4712. Cumberland  
Somerset H.D.

**MONTGOMERY COUNTY HISTORIC PRESERVATION COMMISSION**  
**STAFF REPORT**

| <b>Case Number:</b> | 35/36-12D   | <b>Staff:</b>         | Anne Fothergill |

**PROPOSAL:** Partial demolition and construction of addition and garage

1801 S.F. EXISTING FOOTPRINT UNDER ROOF  
 2185 S.F. PROPOSED FOOTPRINT UNDER ROOF  
 PLUS 440 S.F. PROPOSED DETACHED GARAGE

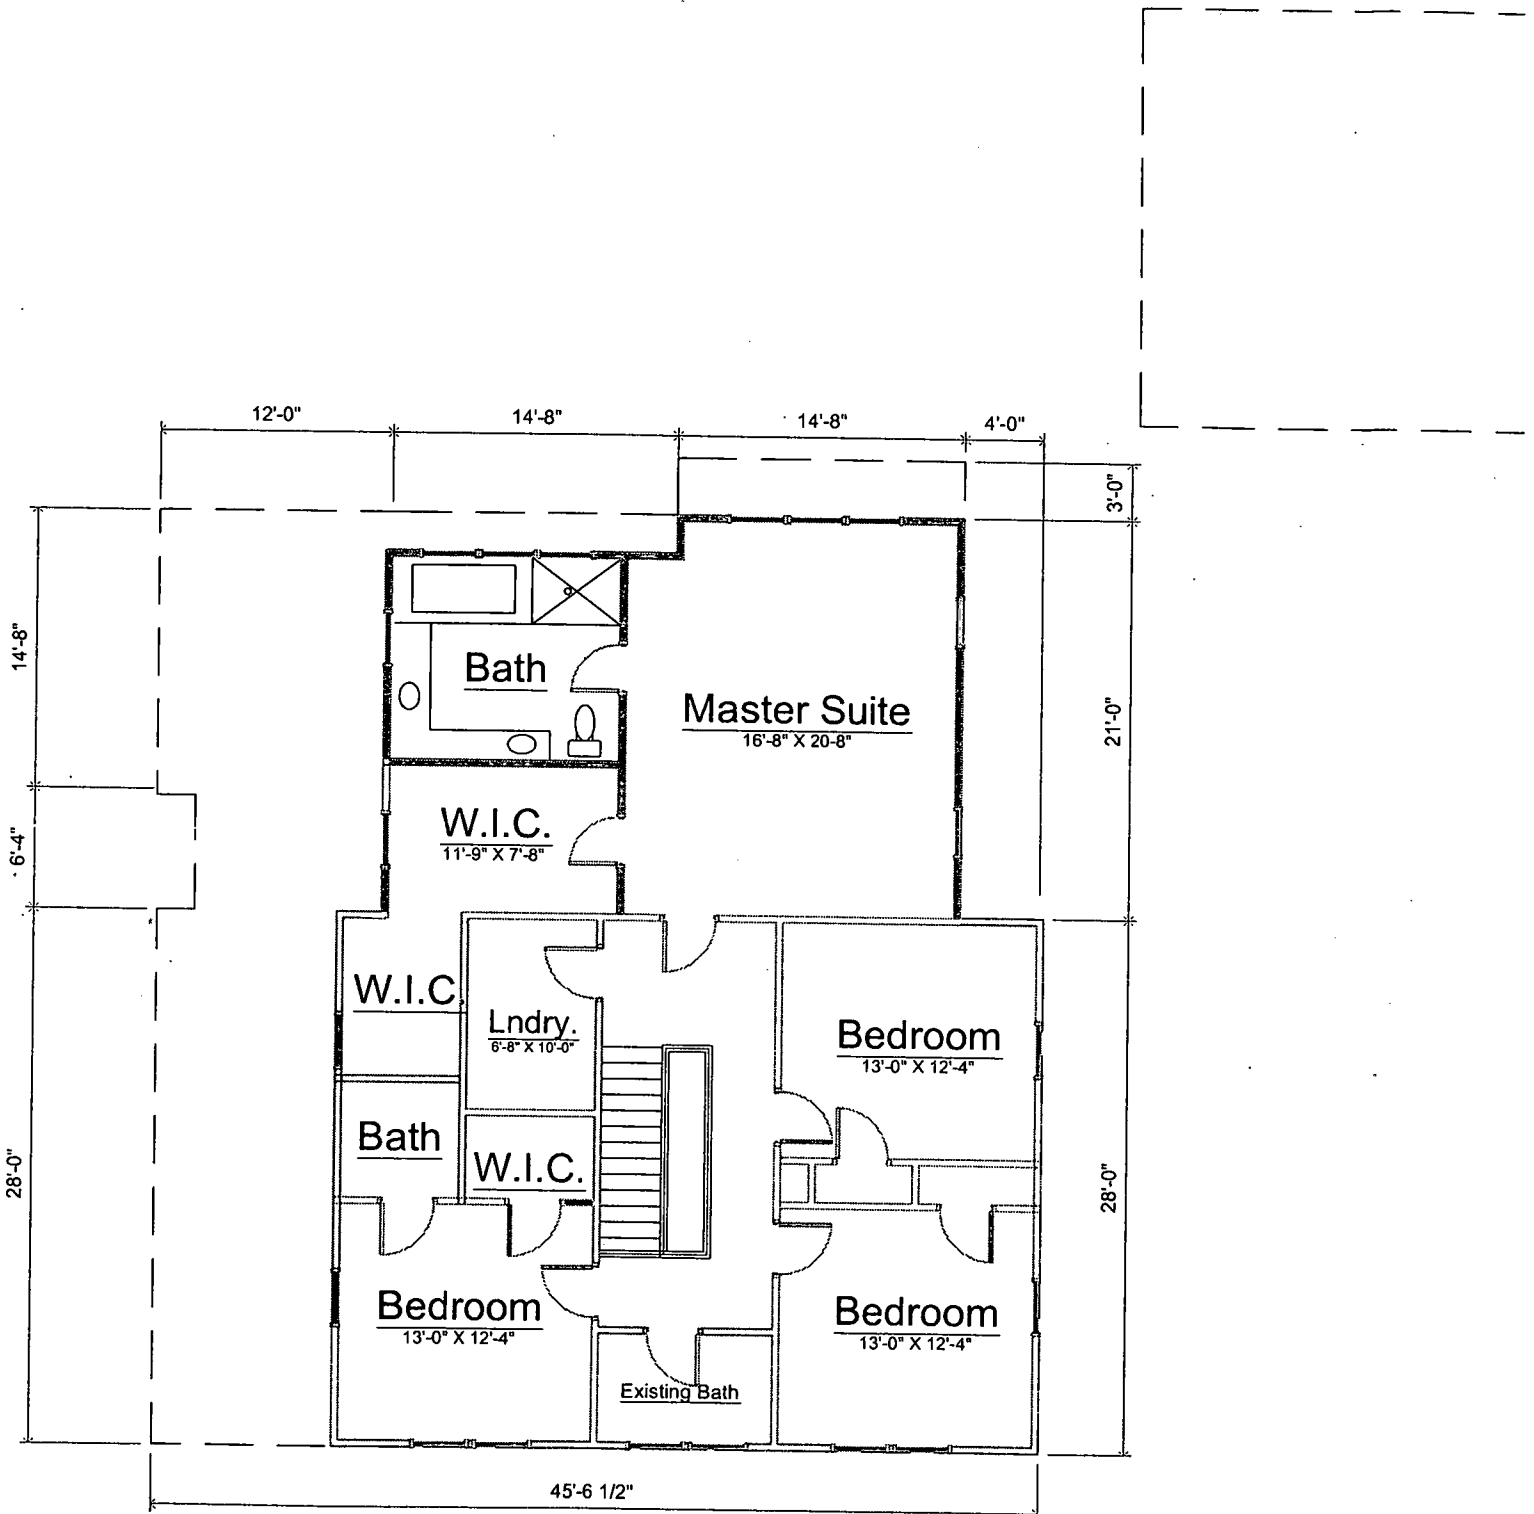
As the design guidelines note, asphalt is generally discouraged for a new driveway and in this case staff encourages the applicants to use pavers, exposed aggregate concrete strips, gravel, or tar and chip for the driveway material. Also, the applicants will need to provide more detailed information for the wood garage doors.

April 25, 2012 HAWP approved with three conditions of approval

1. the infill area below and around the new windows (in existing garage door area) will be STUCCO
2. the new garage doors will be wood
3. Garage doors to be reviewed and approved at the staff level

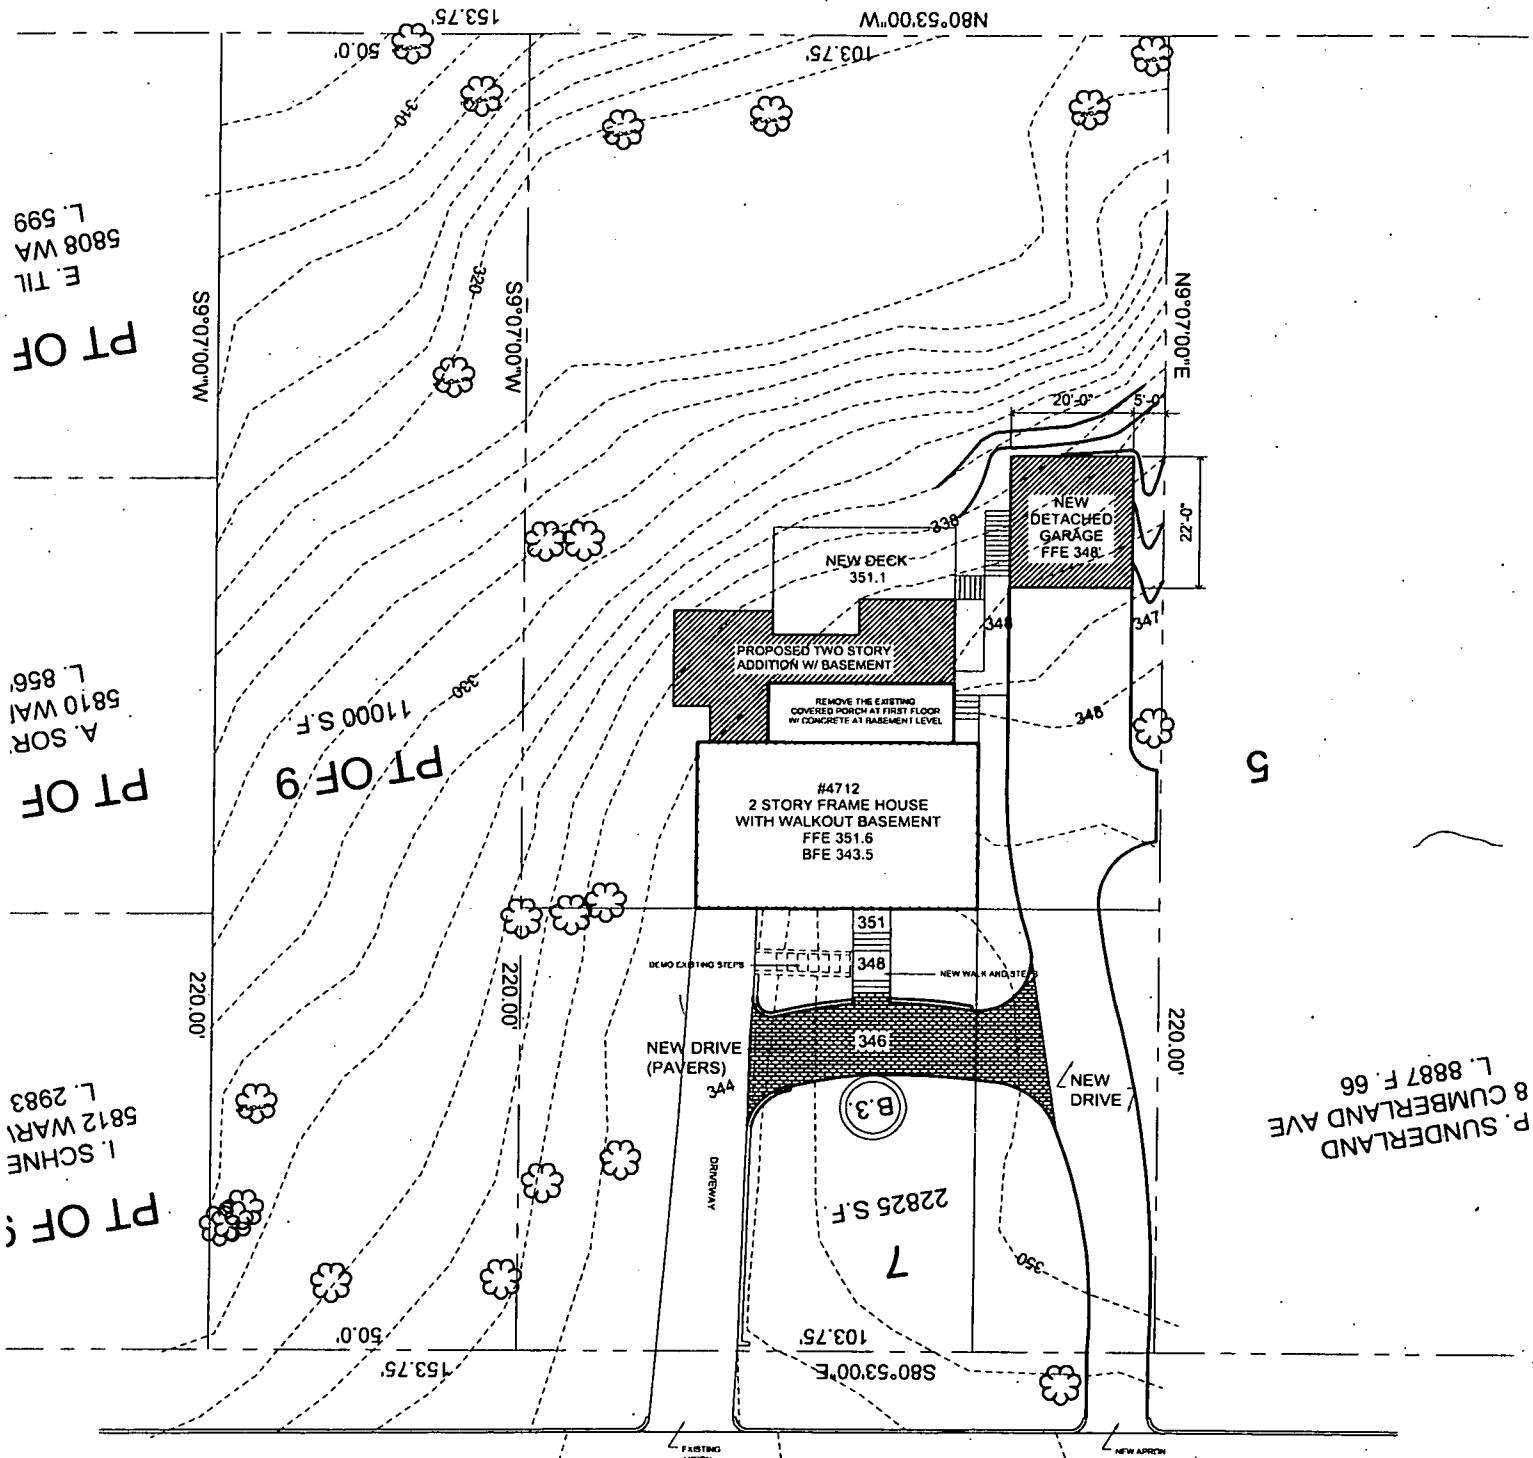
I do think the driveway, at this point, is my biggest concern as it's drawn currently. I think you're essentially creating a grand canyon in front of the house. It seems like a fairly deep, those would need to be fairly high retaining walls to let that pass in front of the house. Am I correct on that?

MR. SWIFT: I think we need to see renderings, and you know, and maybe some idea of landscape and see. In some ways it's possible that may be hidden from the street but I'm not sure it's the most ideal. And then I guess I do agree with only a single driveway and I think I need to see more of how this, I guess, how the -- if the pass-way in front of the house is moved towards the street, I'd certainly want to see more of that as far as rendering and some more details to see how that's going to change. I guess this viewpoint and -- my only other thought on the driveway is that we have pushed that the existing garage is a character defining aspect and to essentially abandon it, to isolate it as not having a driveway to it, I'm not sure if that's what other Commissioners have been speaking to and maybe they can comment further, but it seems to completely eliminate that as a useable garage. It may not be making sense if it's a character defining aspect.

MR. KIRWAN: Okay, well, to start off with the driveway. I mean, as I already gave away my position on that, I think it's critical if the garage is going to be on the side which I think is a big improvement to the schemes you've had before. I think overall this is a much better scheme, much better approach, and in response to a lot of the things we were concerned about before. So, if the garage is going to be on that side, I think that it's critical that the driveway come straight in? And whether they later on might allow you to keep the existing curb cut or not, I think the new driveway is on that right side, I'll have a hard time approving the circular driveway concept; because, again, it's going to take so much grading work to get that connecting driveway in. As Commissioner Swift mentioned, it really will have a canyon effect in that front yard. I think that would be unfortunate to lose that very nice lawn that leads up to the front door.

And while we're on that image, there was some questions asked of the Commission to look at the roof slope of the garage and its scale and, you know, I think while there may be some advantage to picking up on the same pitches, we often encourage that on projects, I think in the case of this garage, you have such a hard time from, especially from the street seeing that gable end, that it's actually better with a lower ridge the way you've got it. So, I would keep that as it is. What you might want to look at even further is possibly on the garage, the overhang is reduced a little bit just to further, sort of, bring the scale of that roof sitting on top of that garage down a notch. I don't think the overhang on the garage have to be the same as they are on the house.

You know, I don't think this is a make or break deal for me, but if I had my druthers, I would rather you take your sunroom and not project it beyond the side elevation of the existing porch on the house. Two foot eight seems like it wouldn't be sacrificing too much on that sunroom given all the other spaces there are in the first floor of that house to just keep that facade in line. I think that's a very exposed side of the house and I think the more we keep the back addition, you know, beyond the face of the side plane of the house the better it will be and the less impact it'll have on the streetscape.

And I think the staff also asked us to consider trees on the property. I'm not sure I have enough information yet in the packet to even make any judgments about trees. I think the site plan shows me little broccoli heads that don't have any size next to them or anything else. So I think a proper topographic survey identifying trees and their sizes and types would be very important to have in order to make any judgment about trees on the property.

MR. RODRIGUEZ: Yeah, I definitely think that you need to look at the driveway. The garage makes sense where you have placed it, but my recommendation is if you need a driveway to be on that side then you have to give up the other driveway and landscape and change the whole

I do have issues with the way you're treating the garage. I think when I look at the site plan, I look at the relationship of the garage regarding the house; I think it's slightly too further back. It might need to come forward and I think the suggestion from staff that maybe the new driveway slopes down and pushes the garage further into the ground making use of the slope that is already there will help to reduce the scale.

I definitely agree that the sunroom shall not project beyond the plane of the house and I

think that you need to look at the roof. The treatment of the roofs are problematic mostly when I see this second floor, the second floor makes me think that that projection of 24 feet back, the extension of 24 feet, Anne, can you come back one? In the second floor plan, the master suite looks out of proportions. Basically, when I look at this plan, my first reaction is, this is too deep? It's going far back too much.

MS. MILES: I have a couple thoughts, I mean, I certainly cannot account for having two driveways or having a front yard filled with asphalt or having a serpentine or circular or any other approach to connect these driveways. I do think that you have a lot of options with your existing space. I think that possibly the first preliminary I proposed that you could essentially make this garage longer and you could retain the garage in that space. I don't think you have to do that but I think you could keep the garage appearance there, remove the driveway, and replace it with permeable pavers that would look probably as it originally looked and continue to use that space for bicycles and lawnmowers and gardening equipment and it would be actually kind of a charming transitional use. Or, you could just obliterate it, in my opinion, as long as that original massing remains. I think that's the main issue.

I don't have a problem having the garage relocated. I do think it should be lower within the site. I do think it should relate to the house better, but I think it's fine to have a new garage essentially in that location.

I would agree that the sunroom should be pulled in so that it is no longer beyond the plane of the existing house to the left elevation and I also do agree that the master suite is making the rear too large and making the roof line too large and it's an awkward sized room even. I think that internally the program is not going to work as well.

So, I would say those are my comments and I don't have any objection to the retaining wall for the garage, and I would also like to see more information about trees before I would comment on trees. And, I think you've got a pretty strong unanimity on most issues, okay? Any additional questions?

Proposed site plan.  
 1"=30'

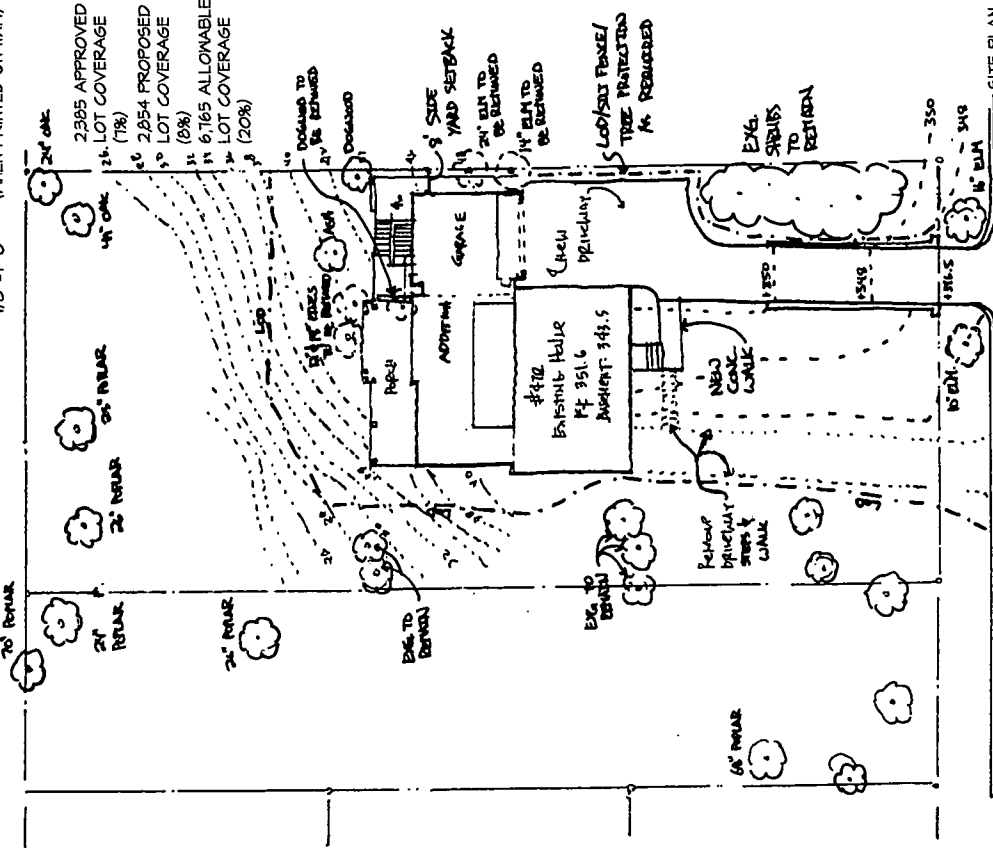
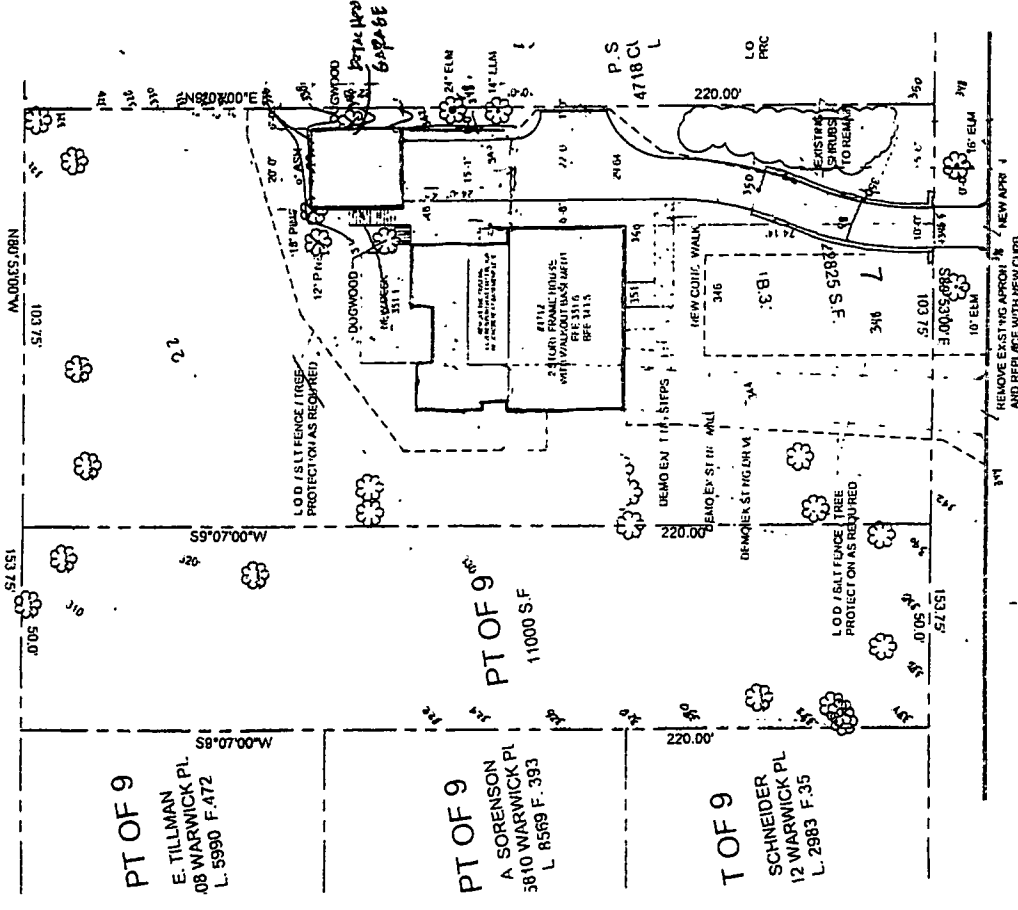
Additionally, the HPC should provide comments on other details of the proposal including the attached garage and its connection at the rear right corner of the house, the driveway size and material, and the stucco on the front elevation (where the garage door is currently).

The applicants should revise the plans based on the HPC's comments and return for a Historic Area Work Permit application.
